**Addendum No. 001**

**Subject: 2020 Classroom Modernizations**  
**SDP Contract Numbers: B-028 C of 19/20 & B-030 C of 19/20**

**Location: Overbrook Educational Center**  
**6722 Lansdowne Ave, Philadelphia PA 19151**

**This Addendum, dated March 6, 2020, shall modify and become part of the Contract Documents for the work of this project. Any items not mentioned herein, or affected by, shall be performed strictly in accordance with the original documents.**

2 ANNEX BUILDING - SECOND FLOOR PATTERN PLANS  
1/4" = 1'-0"

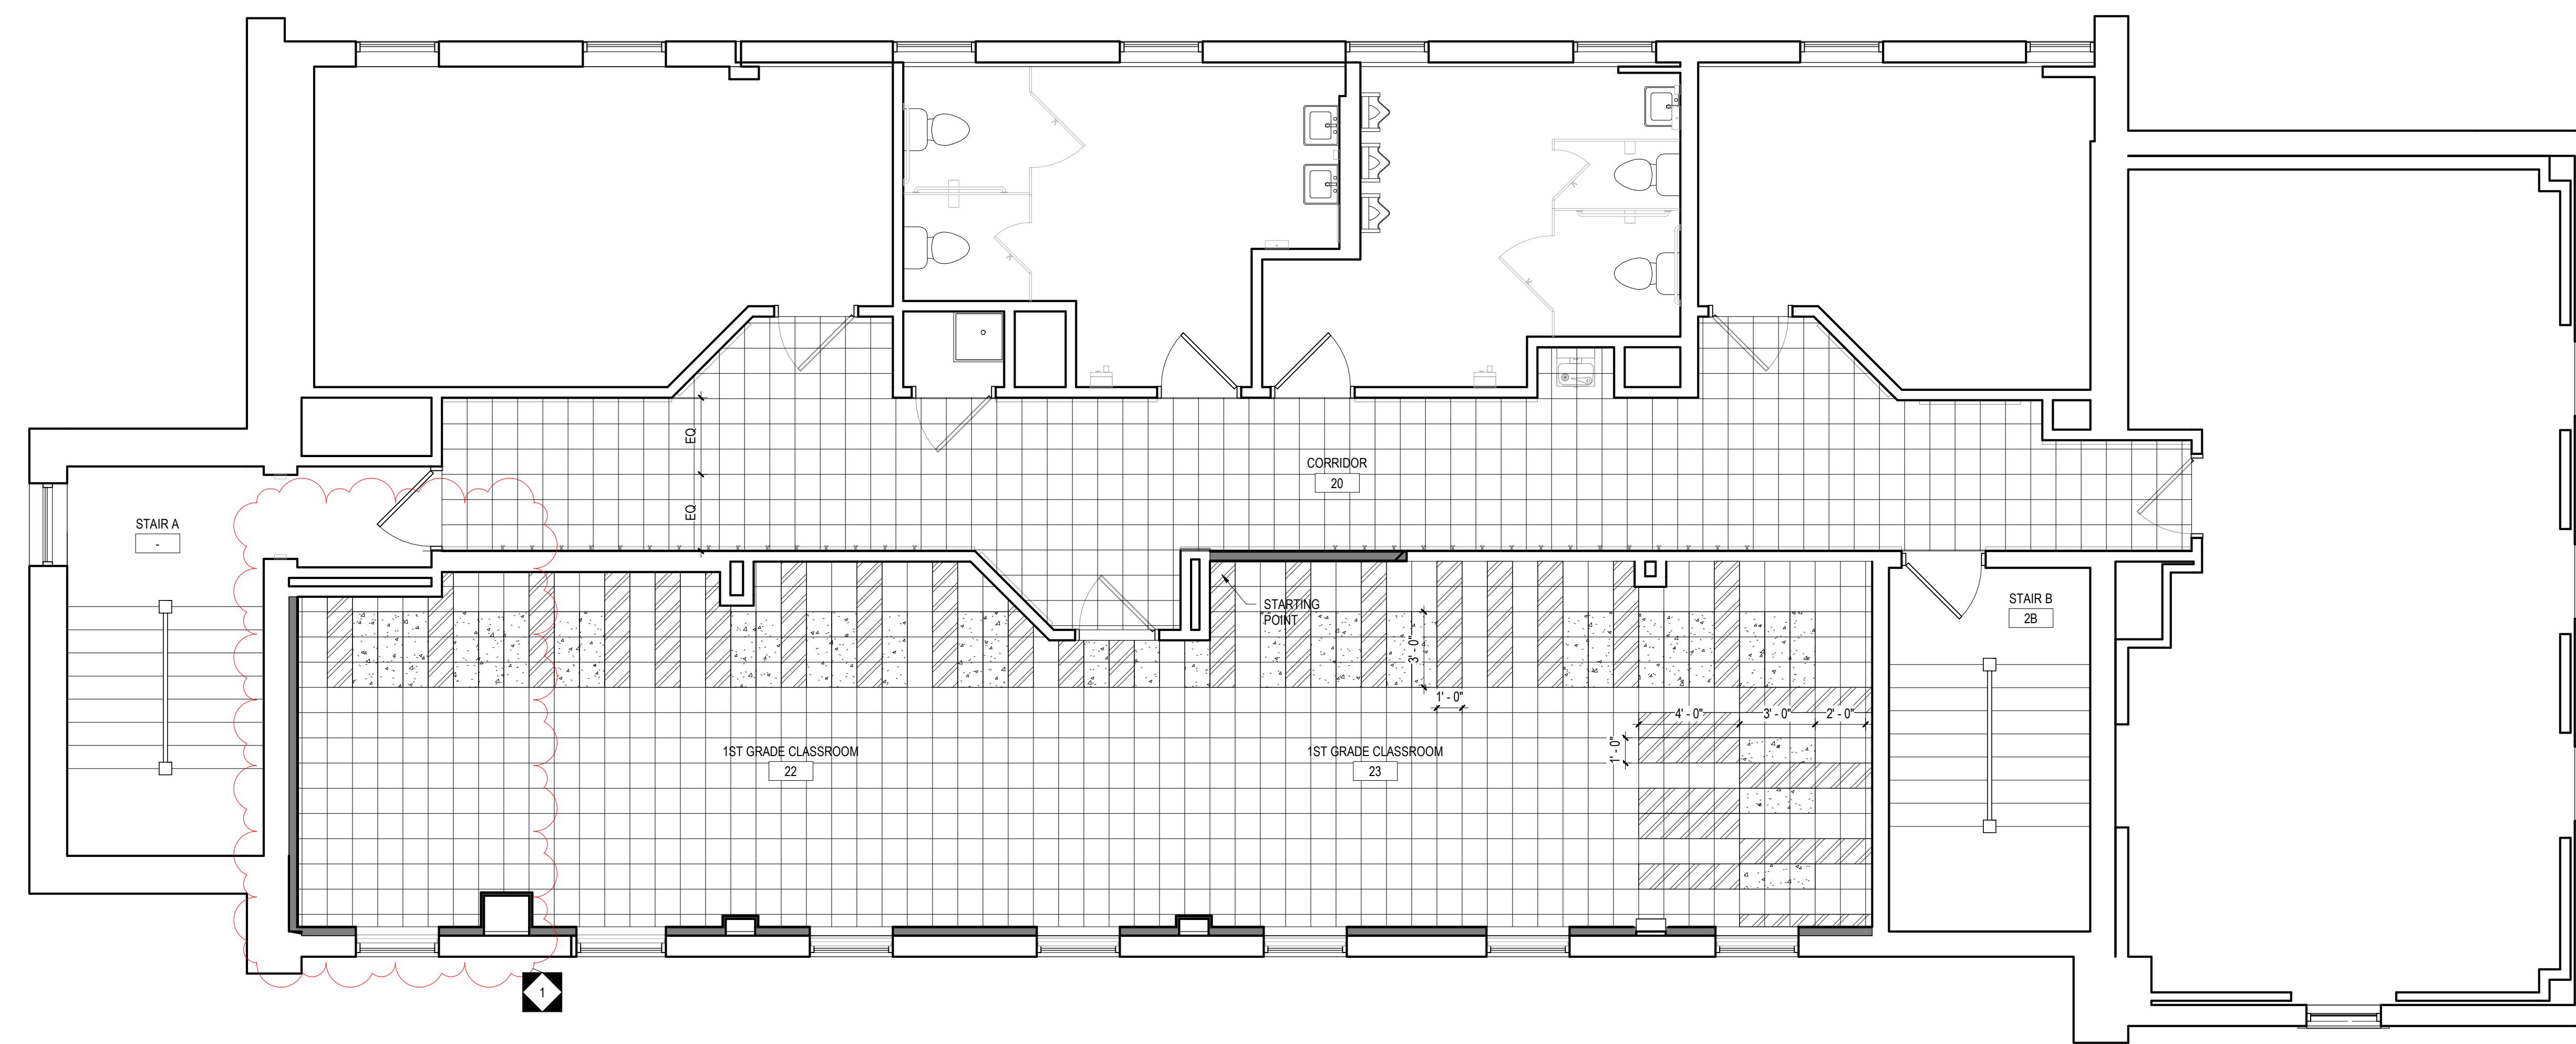
1. REVISE detail 1/I4.3, FIRST GRADE – ROOMS 22 & 23 – Revise accent wall location, smart board locations and visual display boards.
2. ADD “702 MARKERBOARD W/ ALUMINUM FRAME” to I4.3 – GENERAL CASEWORK AND EQUIPMENT SCHEDULE.
3. REVISE detail 2/I4.3, FIRST GRADE – ROOMS 22 & 23 – Revise overall floor pattern plans due to teaching wall layout revision.

2 ANNEX BUILDING - THIRD FLOOR PATTERN PLANS  
1/4" = 1'-0"

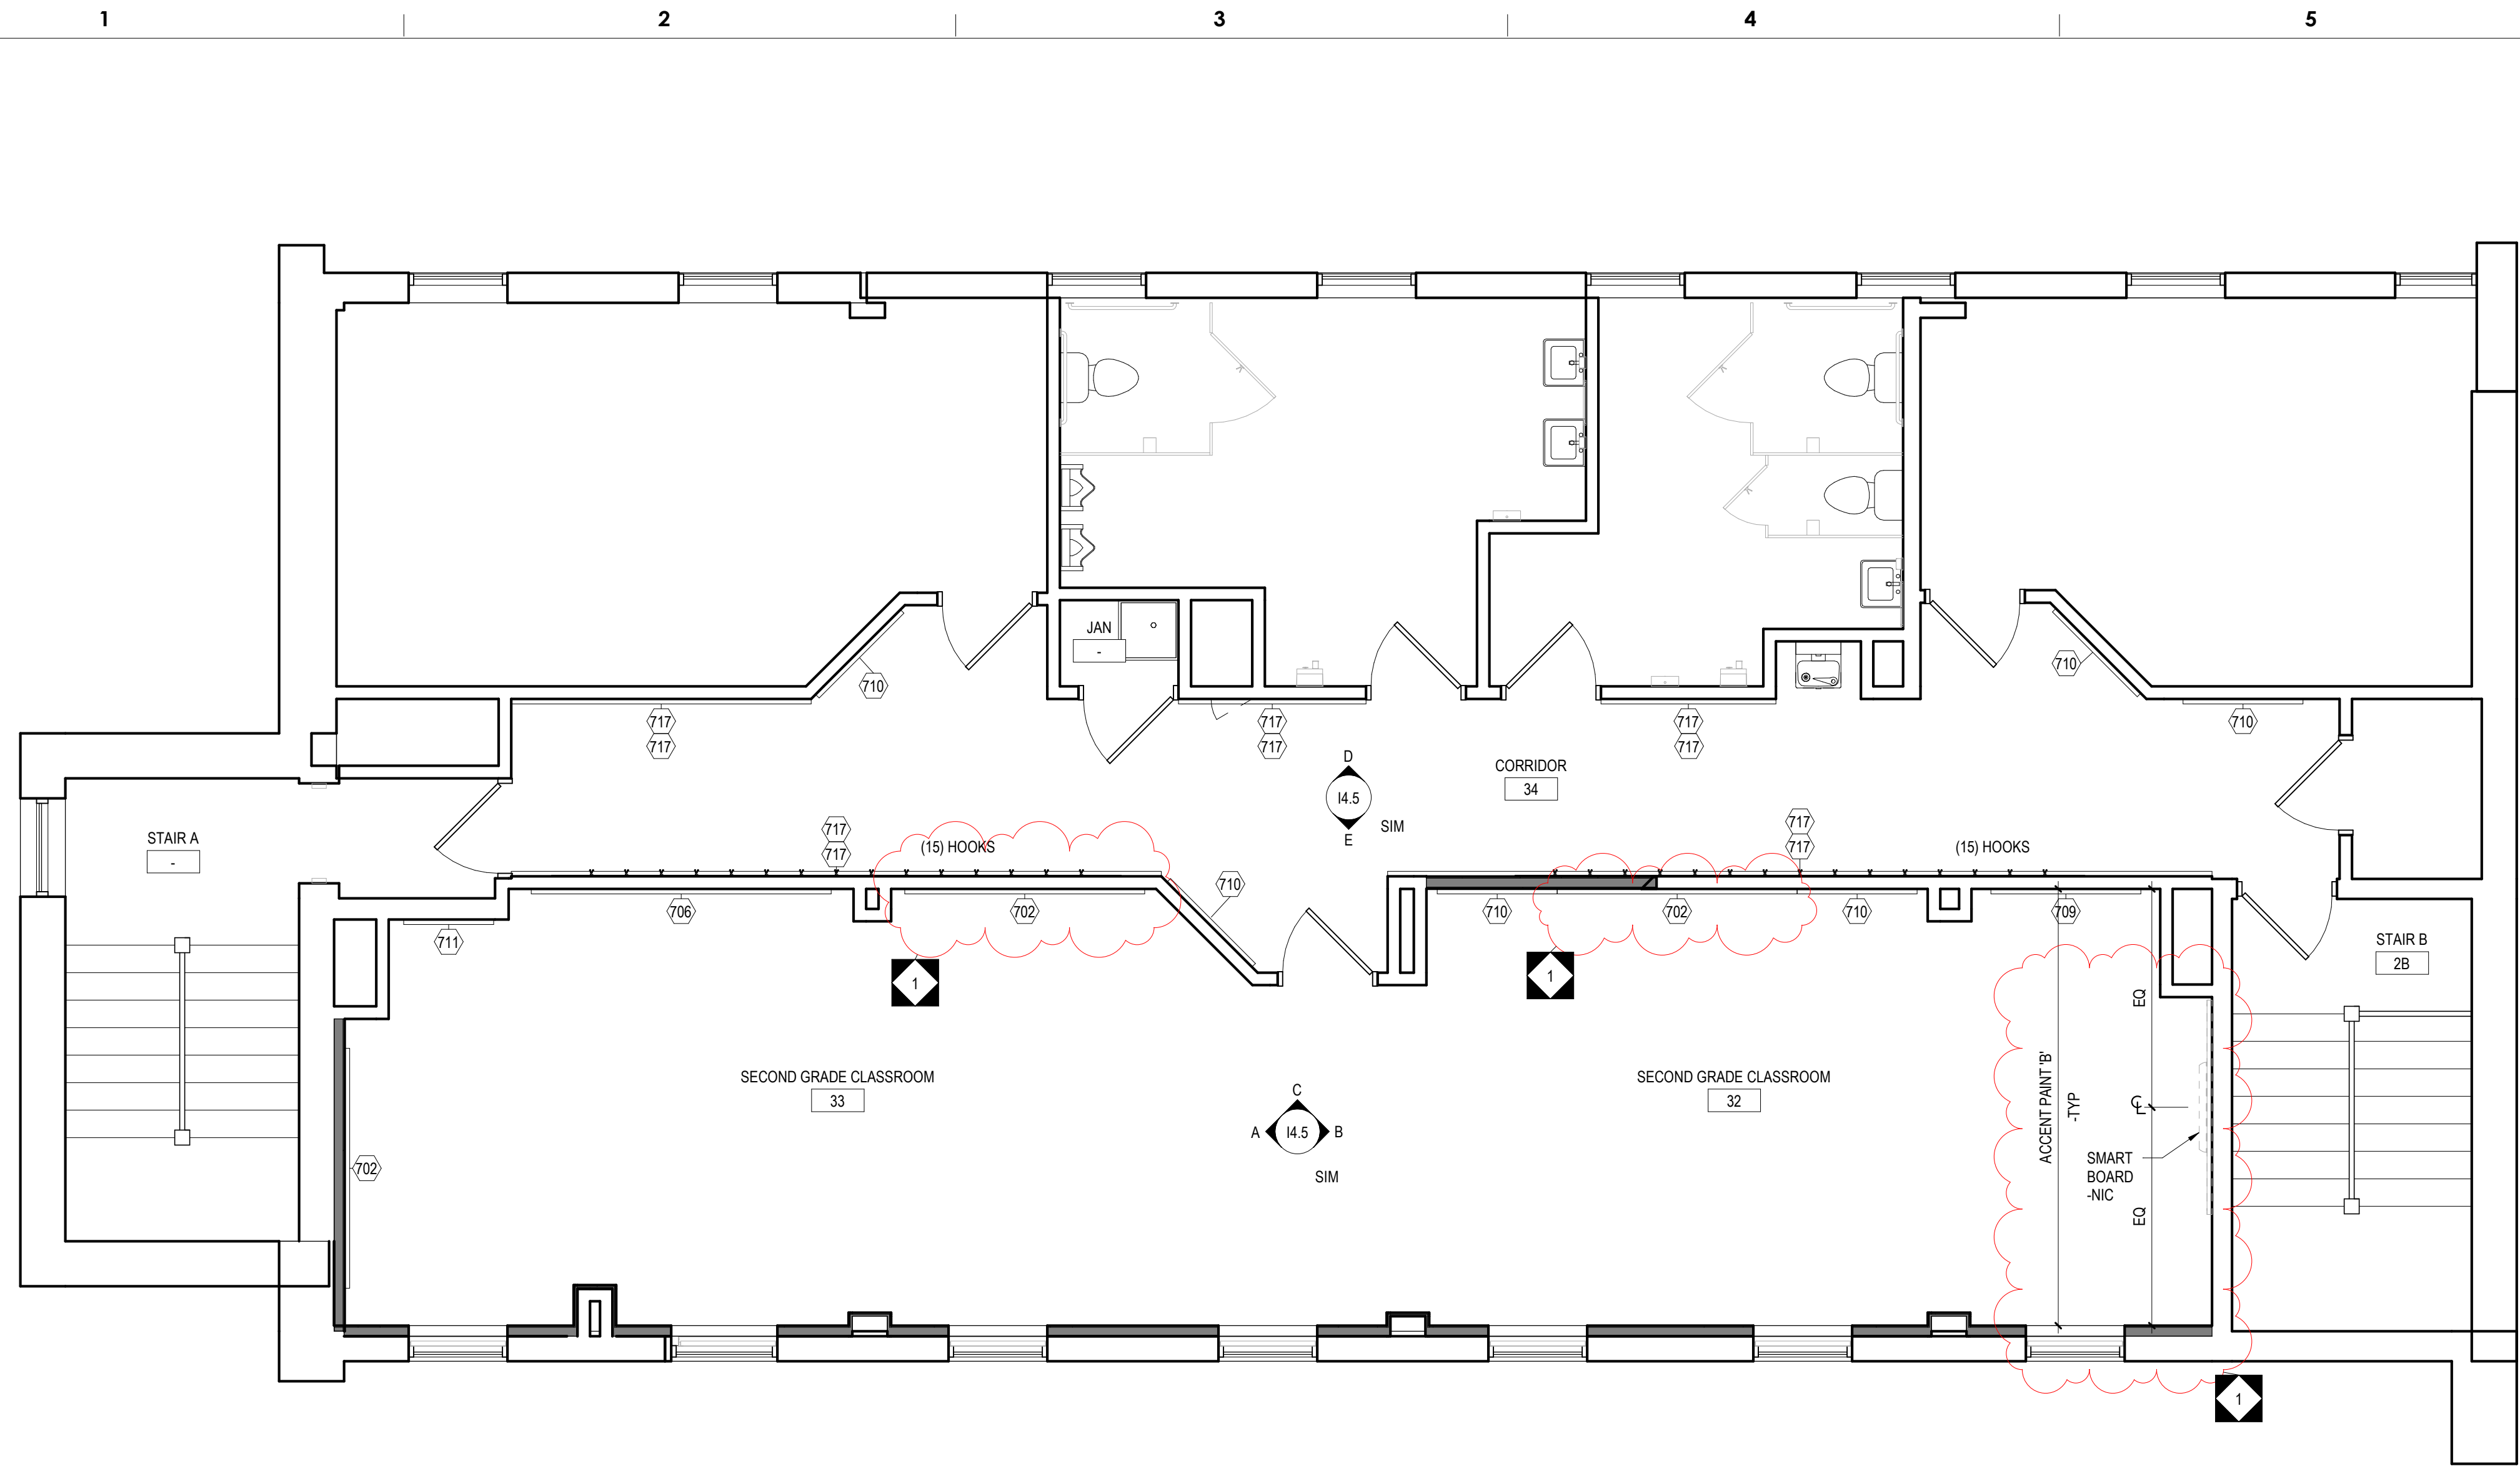
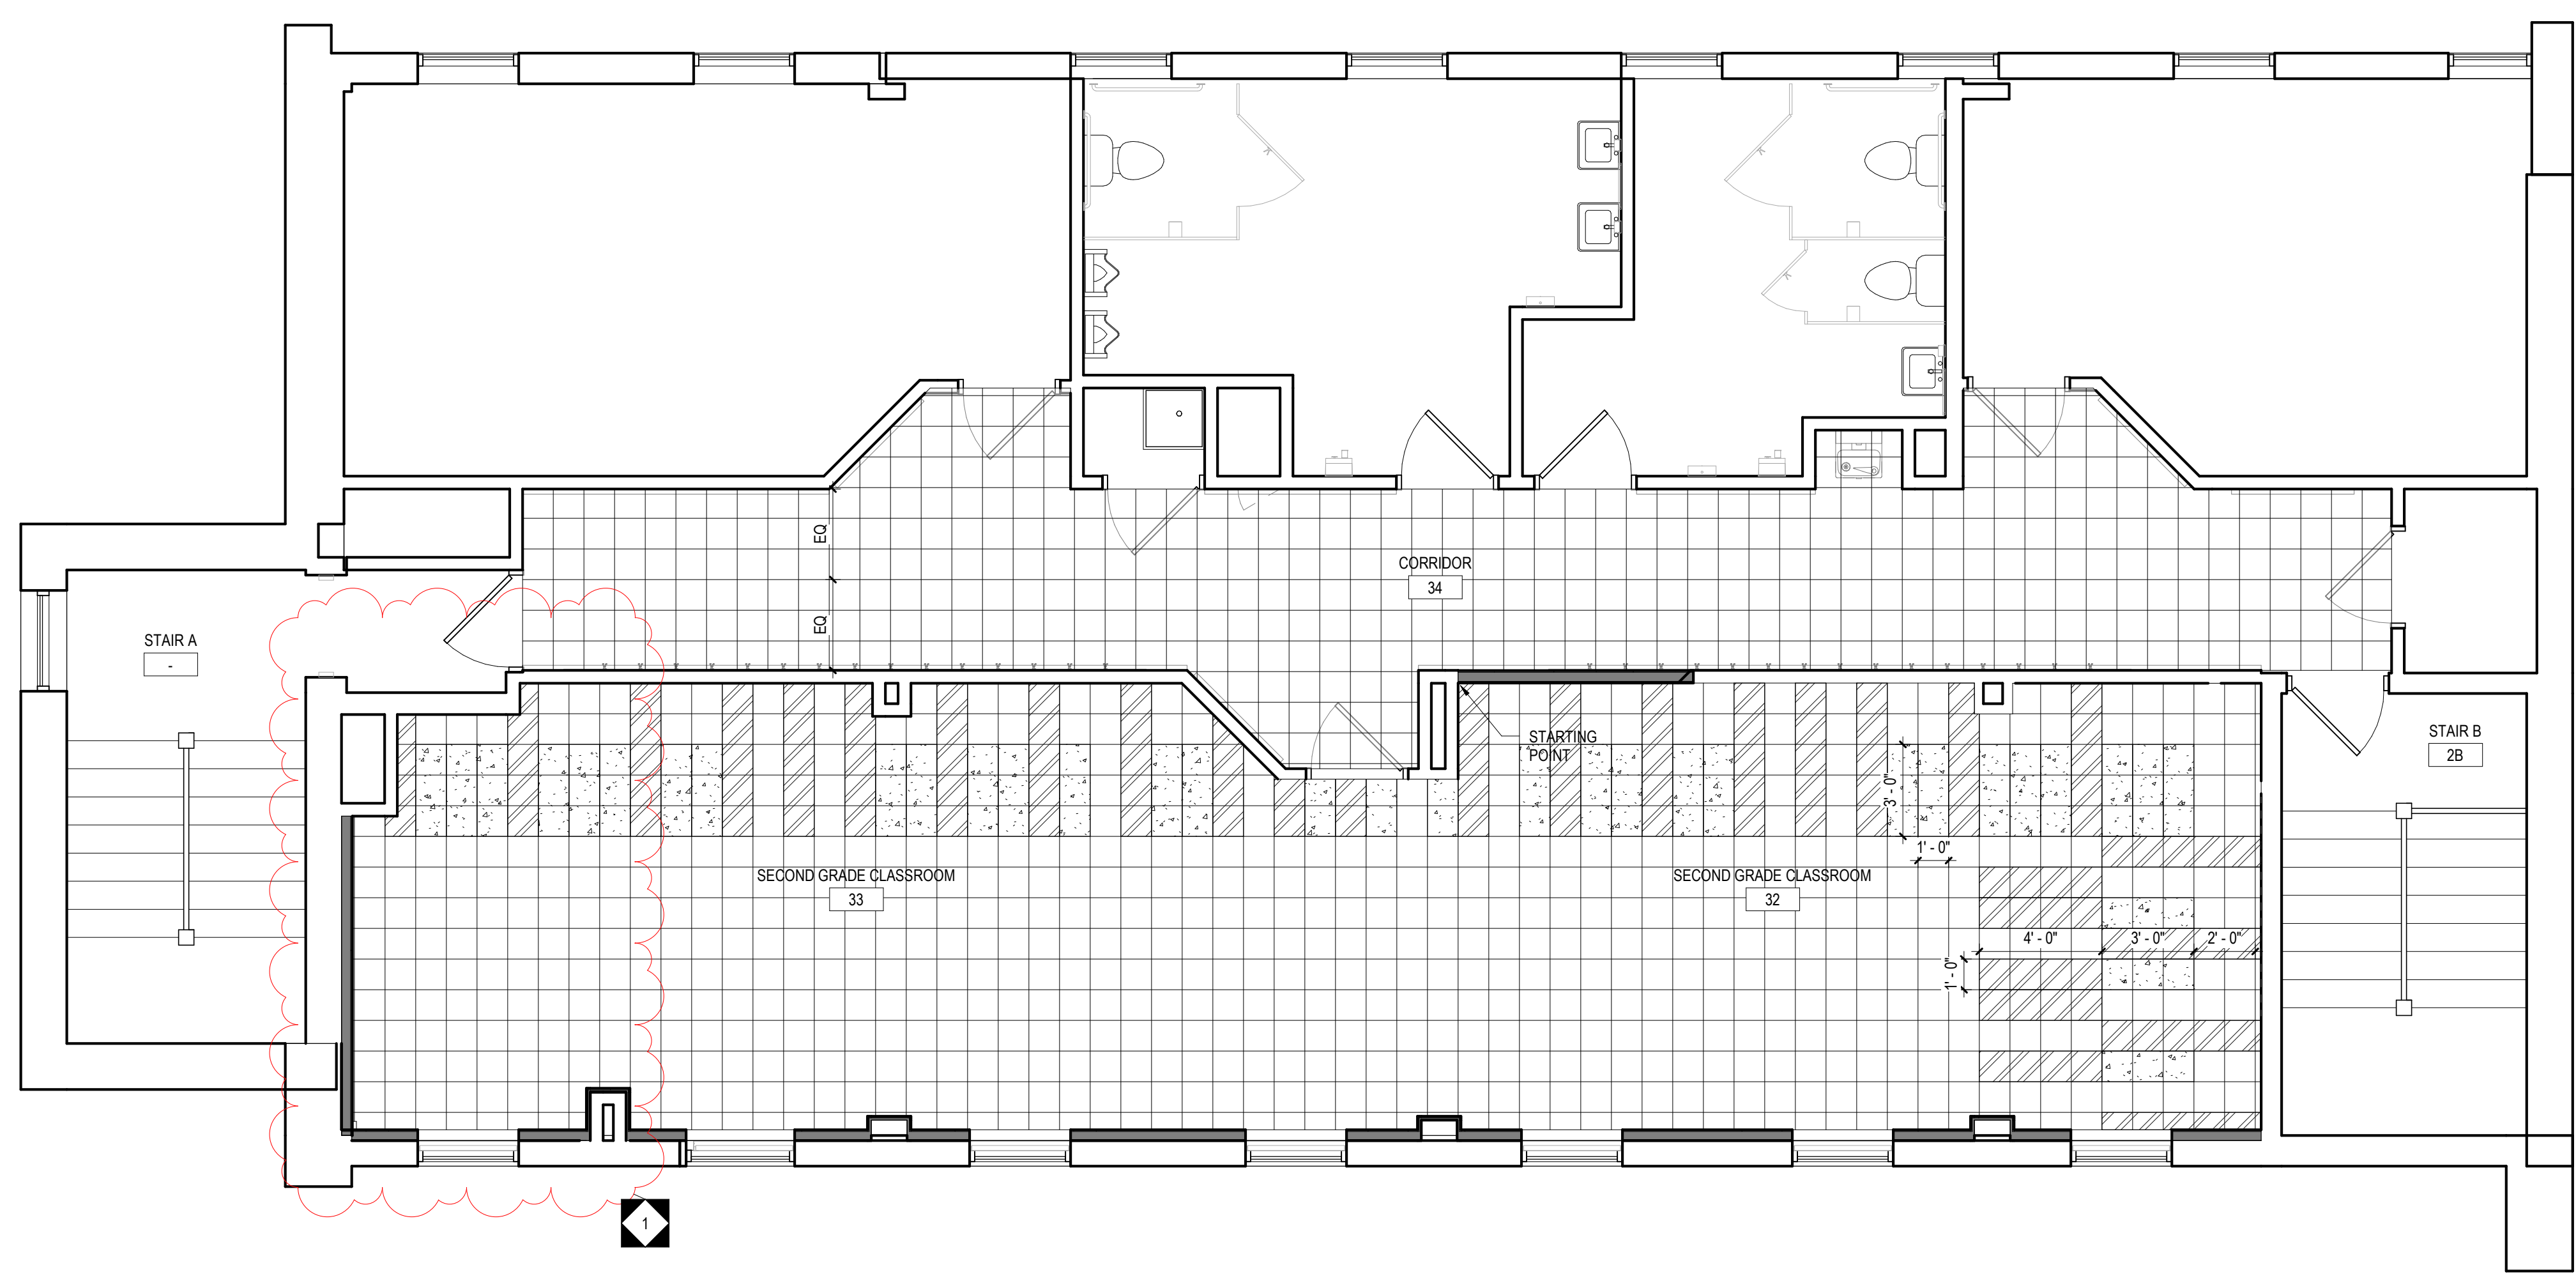
1. REVISE detail 1/I4.4, SECOND GRADE – ROOMS 32 & 33 – Revise accent wall location, smart board locations and visual display boards.
2. REVISE detail 2/I4.4, SECOND GRADE – ROOMS 32 & 33 – Revise overall floor pattern plans due to teaching wall layout revision.
